TEMPORARY ABANDONMENT WELL APPLICATION

May 24, 2022

Re: Temporary Abandonment  
API 15-095-19060-00-00  
JOE T TJADEN 1-24  
NE/4 Sec.24-30S-08W  
Kingman County, Kansas

#1-24

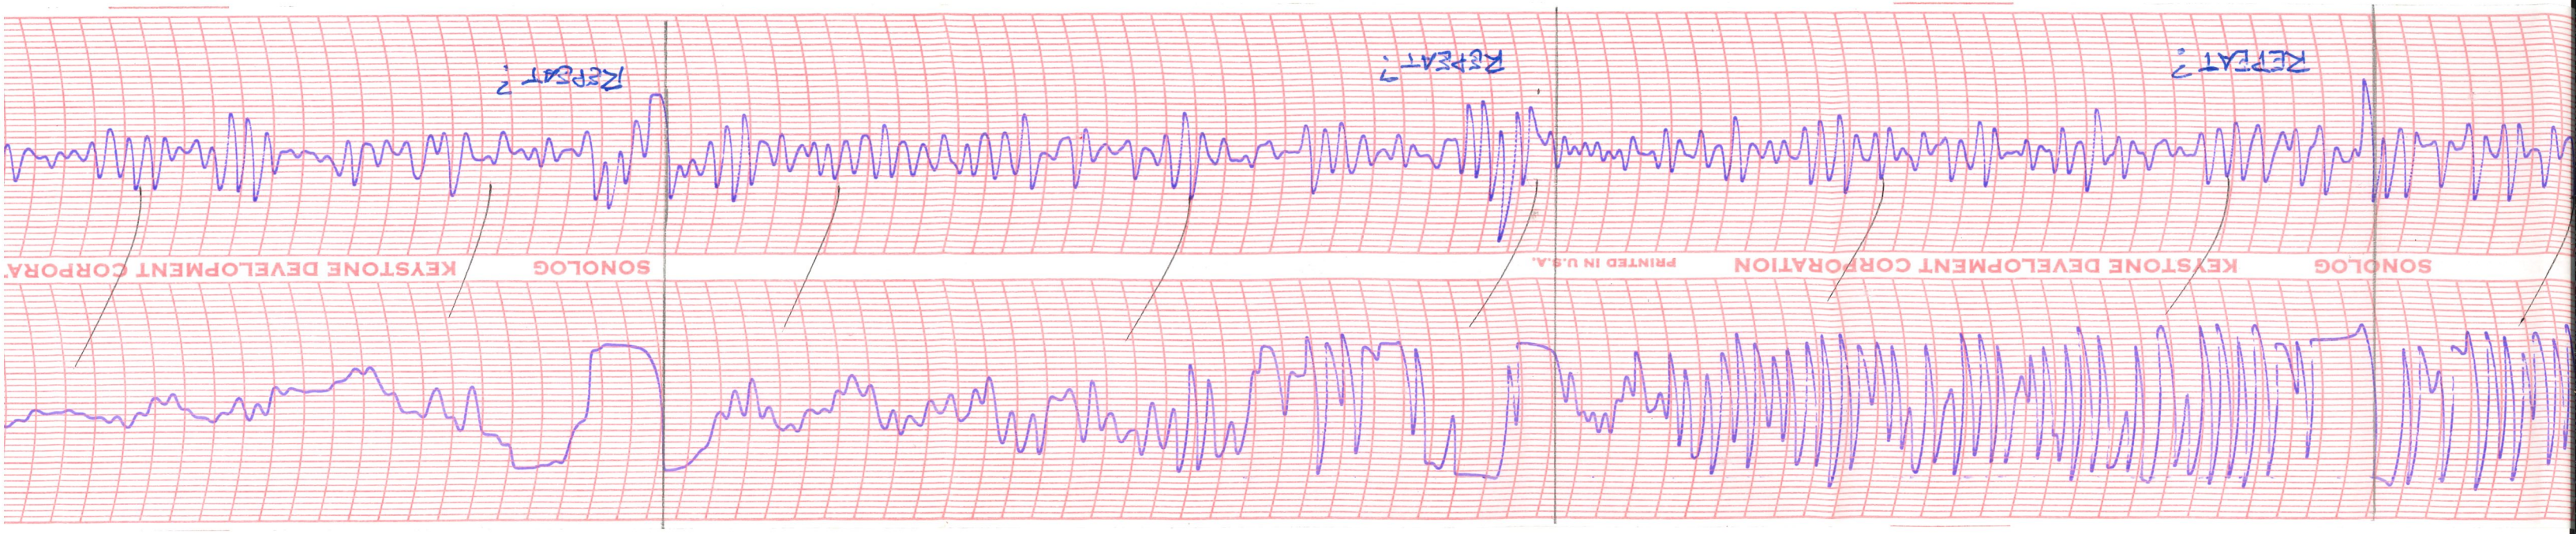
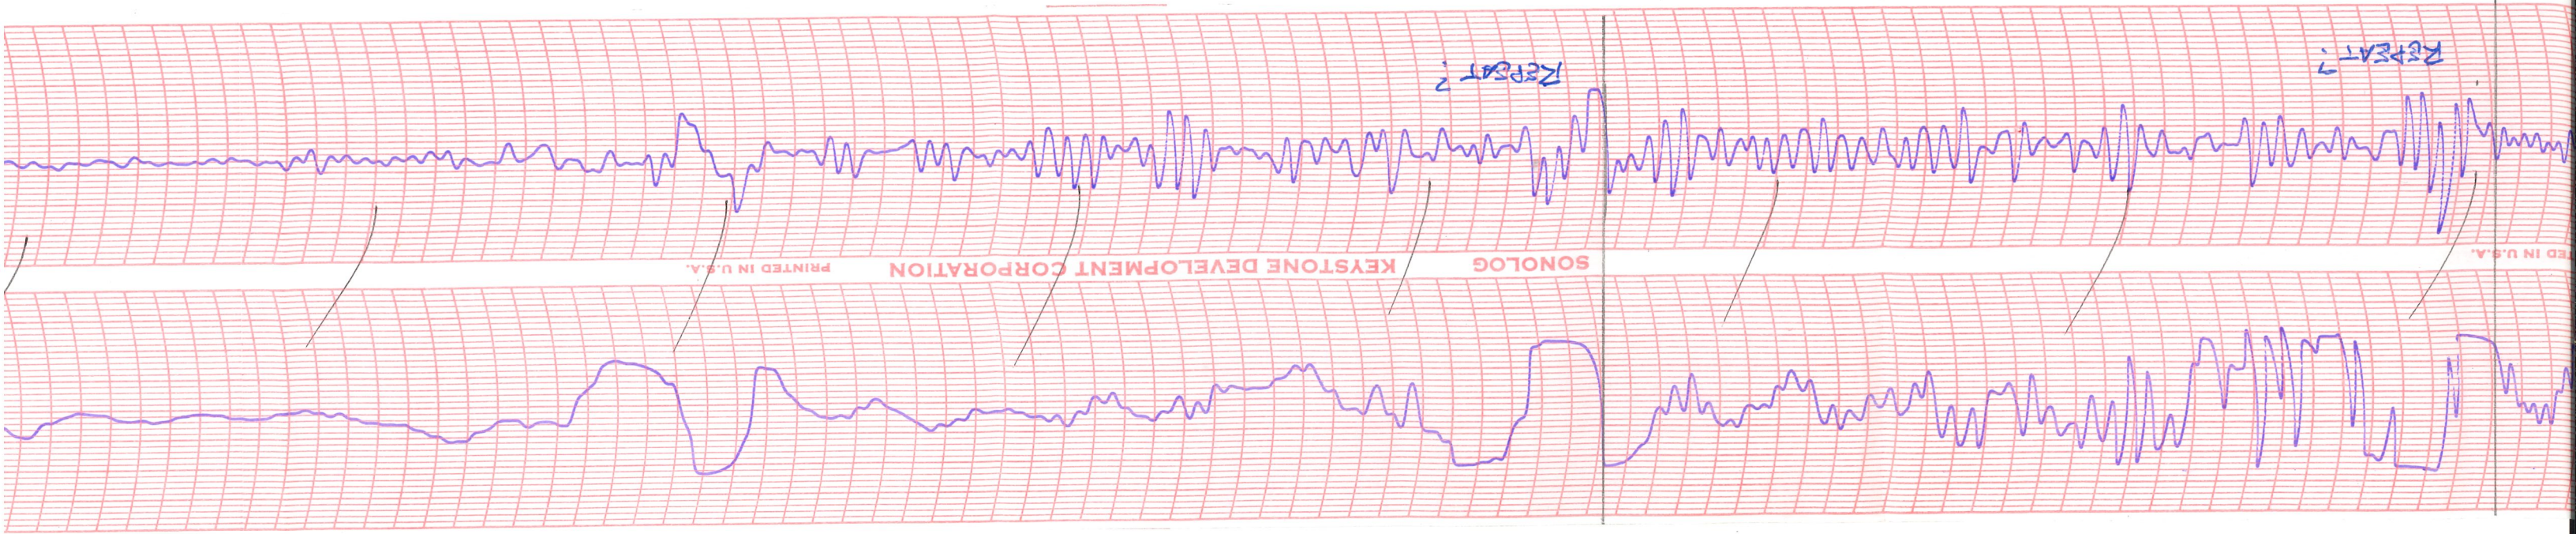
REPEAT?

**Fluid tape showing repeat section, indicating high fluid level**

Pursuant to K.A.R. 82-3-111, the well must be plugged, or returned to service, or obtain temporary abandonment status by 06/23/2022.
